Historic Landmark Commission
April 23, 2012
National Register Historic District
NRD-2012-0038
Old West Austin
3307 Oakmont Boulevard

Construct a new 2,849 sq. ft. house on a vacant lot.

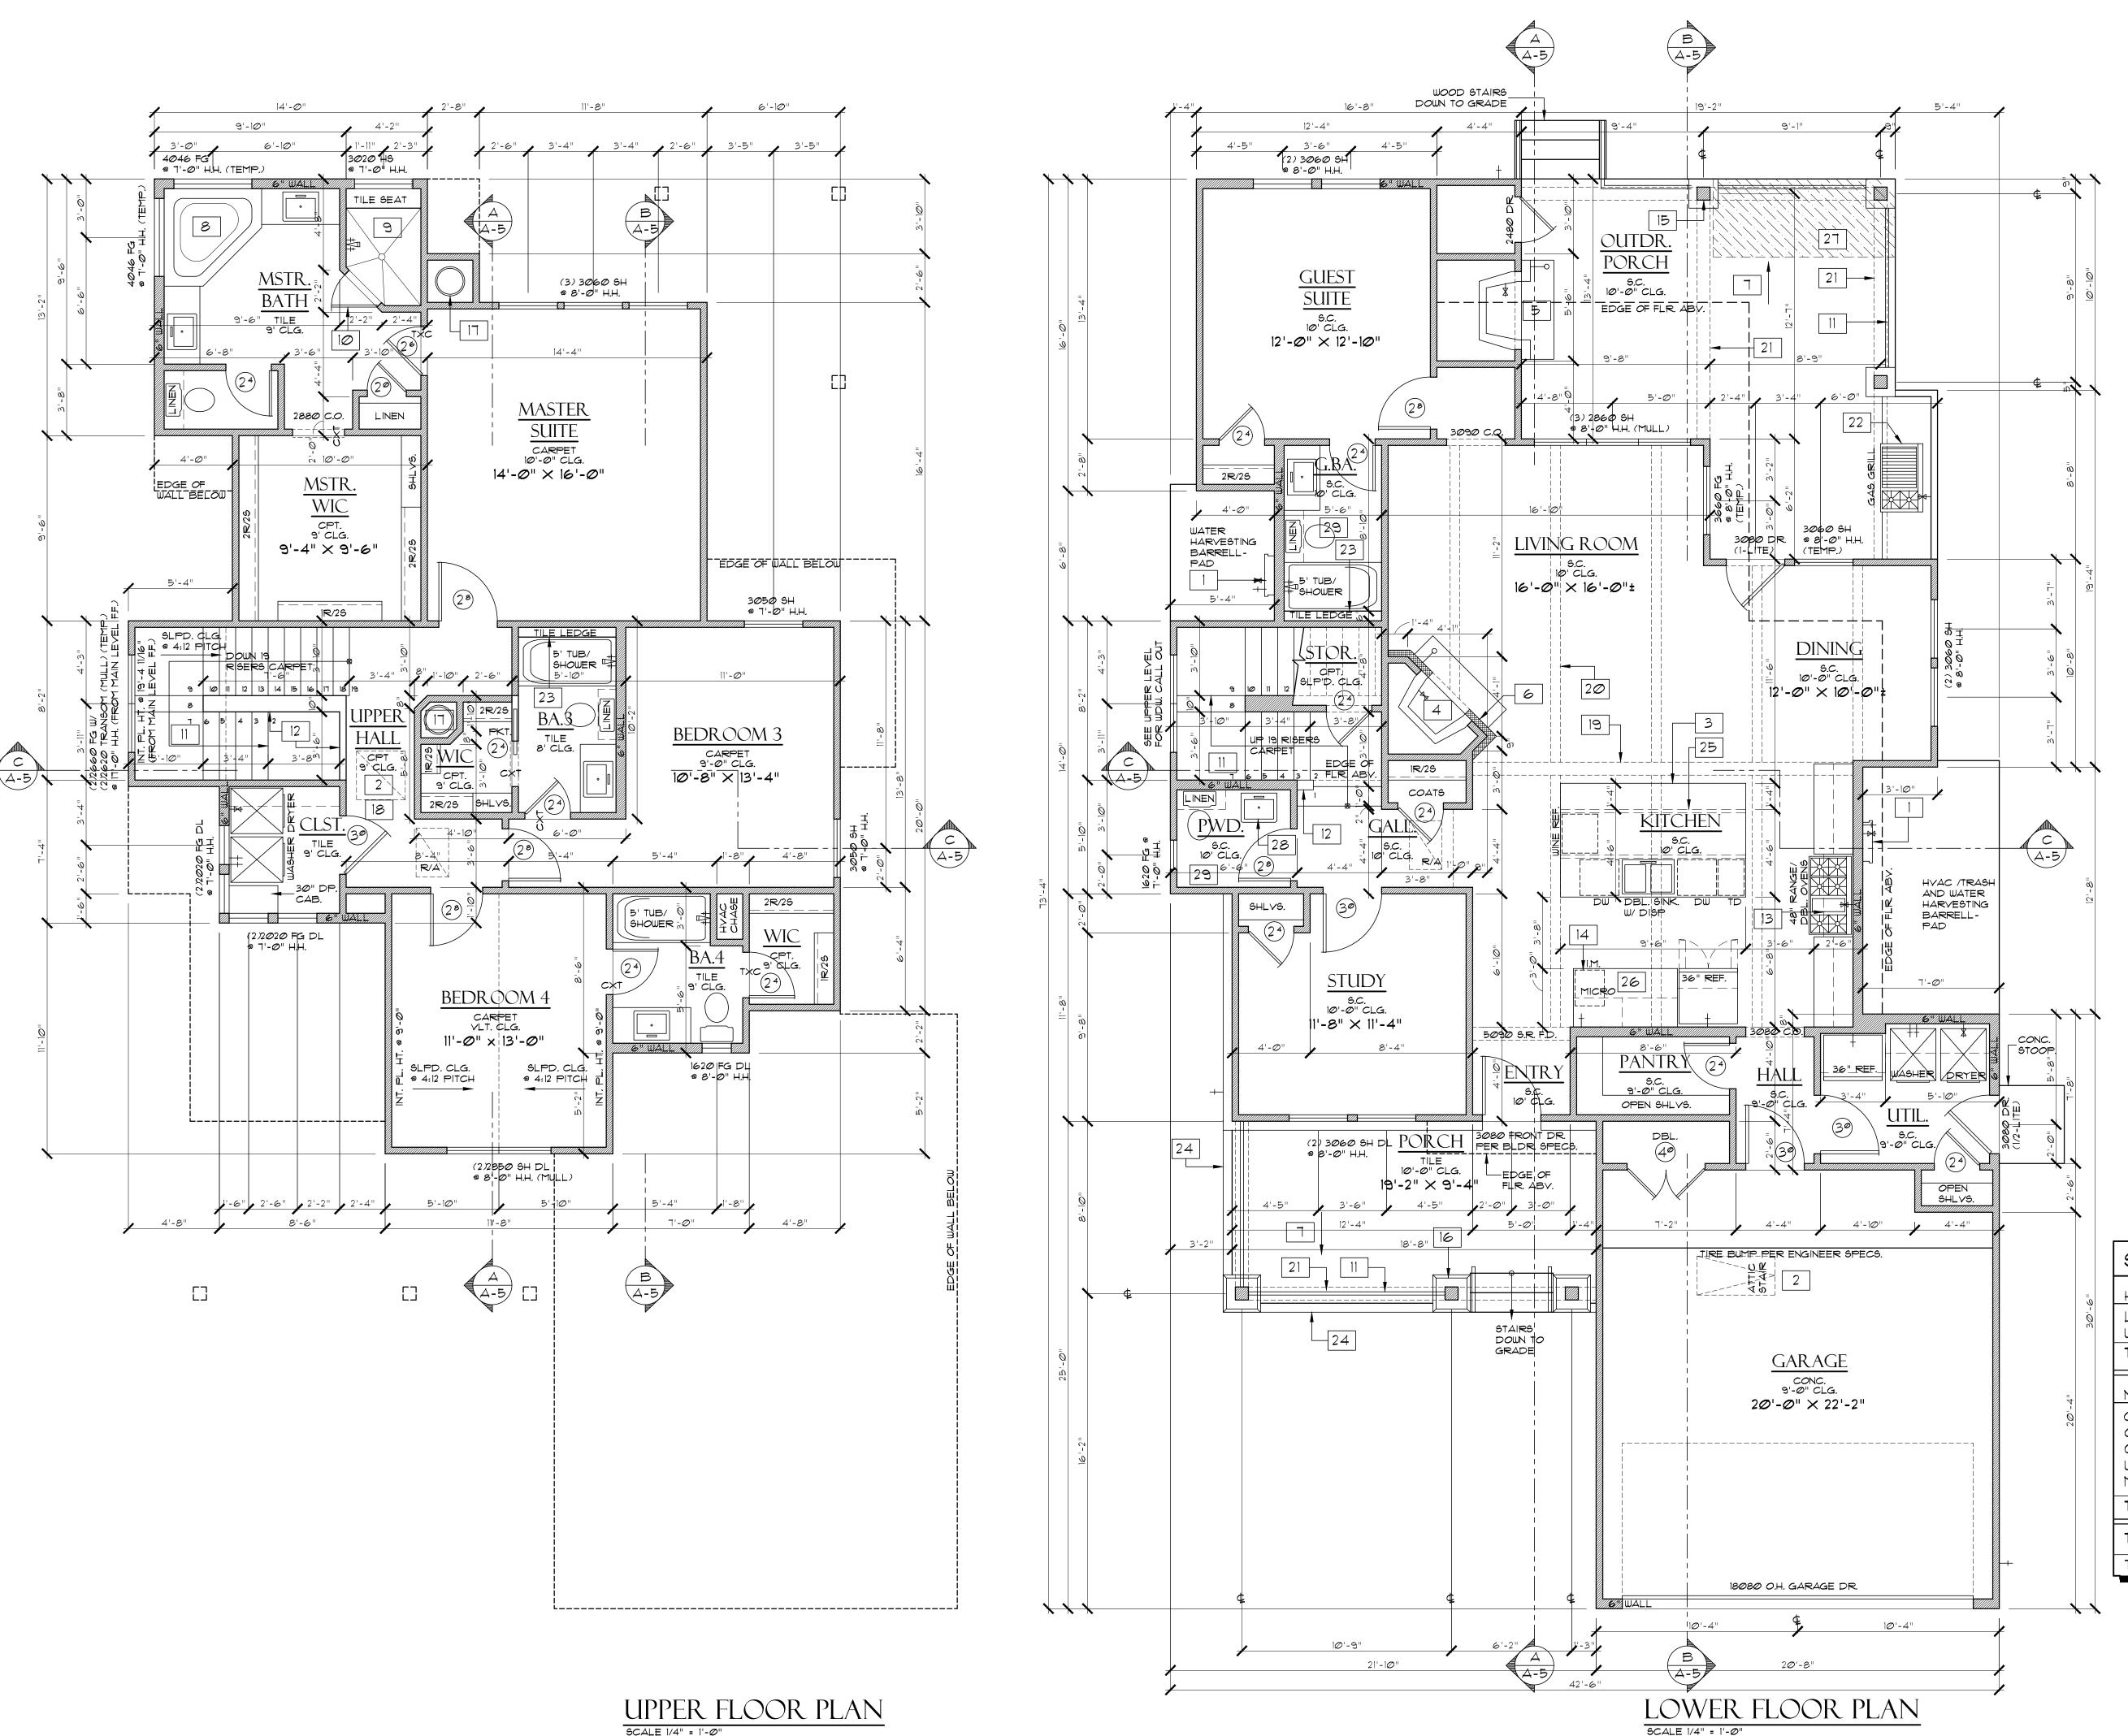
Release the permit, however request the applicant consider moving the garage further back from the front façade.
